Re: PETITION NO. 1247 — C-TEC Solar, LLC petition for a declaratory ruling that no Certificate of Environmental Compatibility and Public Need is required for the proposed construction, maintenance, and operation of a 3.75 MW solar photovoltaic electric generating facility located at 1 Ballard Road, Thompson, Connecticut

RESPONSES TO INTERROGATORIES (SET ONE)

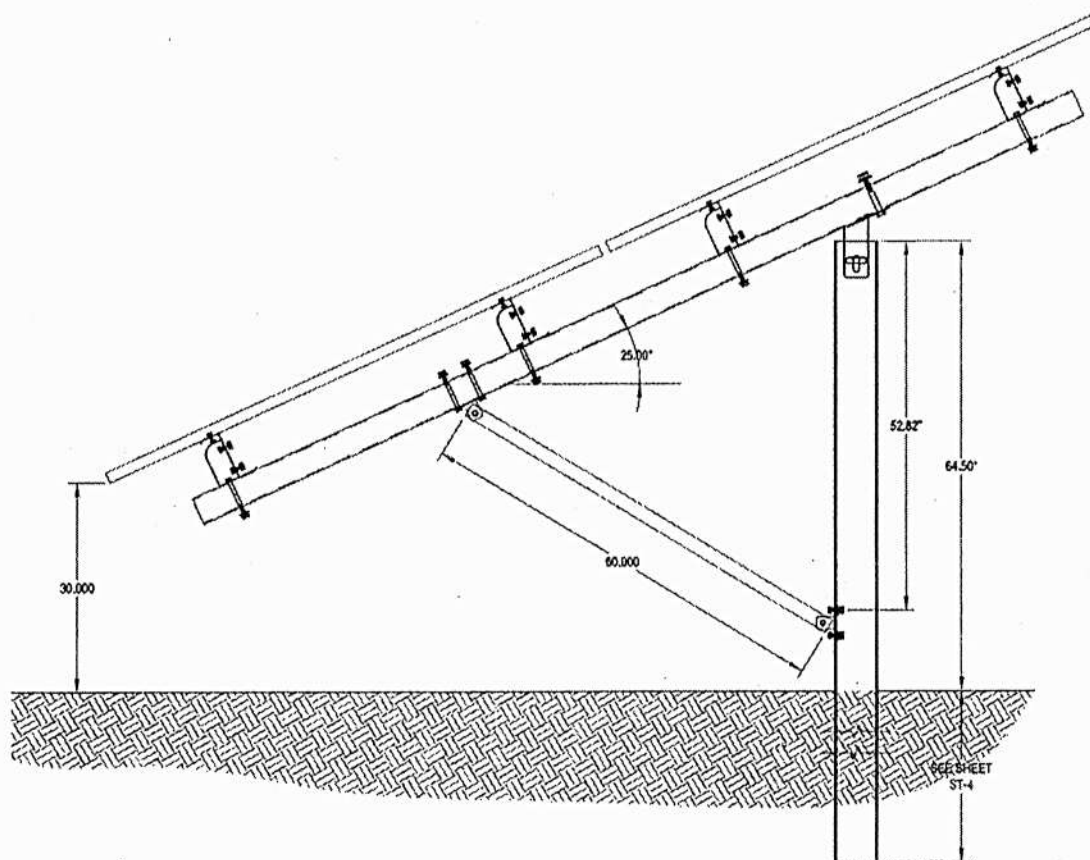
3. Page 28 of the Petition states that, "The solar panels and appurtenances will not exceed a height of six (6) feet above ground." Page 31 of the Environmental Assessment dated July 2016 states that, "The solar panels and appurtenances will not exceed a height of approximately eight (+/-8) feet above ground." Provide the correct maximum height to the top of the solar panels. Would the bottom of the solar panels be approximately two feet above grade per Sheet DN-1?

Response:

- See above. This places the solar panels at approximately 7'10" maximum height.
